<b>T.I. no.:</b> 2022-12 <b>Updated:</b> -	<b>Topic:</b> SCClub Software Version 2.3.2
---	---

<b>Date:</b> 12.04.2022	<b>Priority</b>	<b>Need for action</b>
<b>Affected machines:</b> SCClub	High	As soon as possible
<b>From serial number:</b> -	X Medium	X On next visit to the machine
<b>As of date:</b> Immediately	Low	FYI only

Below please find the documentation concerning the changes compared to software serial version 2.2.3. The new software version has been introduced in series in the meantime.

### Screensaver active for machines in self-service operation with pending error messages

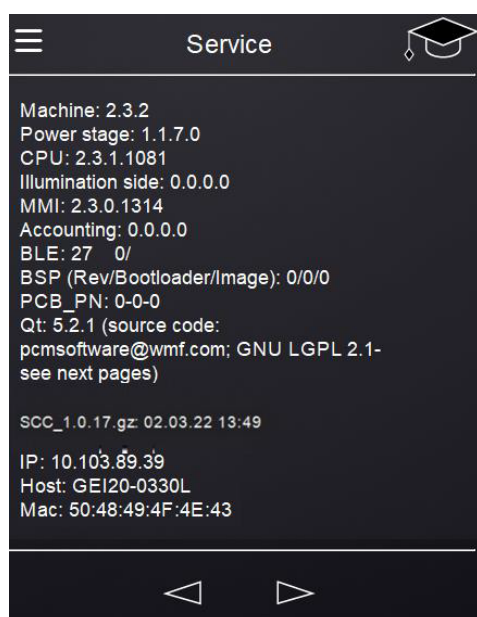
With the previous software versions, with machines in self-service mode, a currently running screensaver was interrupted by an occurring error and the beverage screen was displayed with the warning symbol. For an end customer (in self-service), this display offers no added value in case of an error, so this behaviour has been changed with the new software version.

An error message does not interrupt the screensaver any more, the error message is visible by the warning symbol in the upper right display corner.

In order to visualise the upcoming error, the option can still be used to inform the shop staff of an error message by a blinking light.

#### System > Display and illumination > Illumination > Event message

If the self-service mode is not active, an error message will still interrupt the screensaver.

#### Accounting > Counter

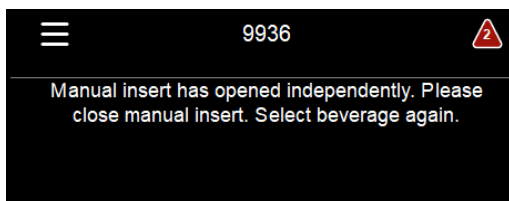
From the field, it was reported to us that if the counter values in the accounting menu under counters are in the 5-digit range, they can no longer be displayed completely.

By changing the font size, it was possible to display a full 5-digit counter reading completely, even if the service PIN was entered previously and thus the 5th counter value (total counter) is also displayed.
